AHG8: RPR Scaling Window Issues

JVET-Q0487

W. Wan, T. Hellman, B. Heng, P. Chen
Brussels, Belgium, January 2020 meeting

Case #2

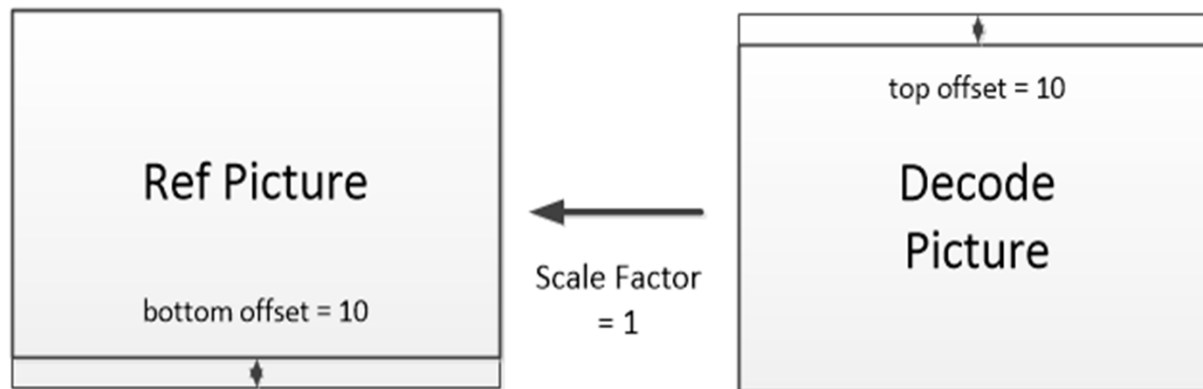
- Same coded picture width and height, same scaling window width and height, but different scaling window offsets

- v1 of contribution thought spec for Case #2 was OK
- Upon further review, discovered DMVR not properly specified
 - None of the motion vector refinement process (Section 8.5.3) uses the scaling window left or top offsets
 - None of the bounding box derivation (Section 8.5.6.3.1) accounts for these offsets either.
 - Unintended use case / not well studied, maybe there are other issues?
- Assert no practical reason and potential complexity to support switching padding from top to bottom as in Case #2
- Propose disabling DMVR for case #2
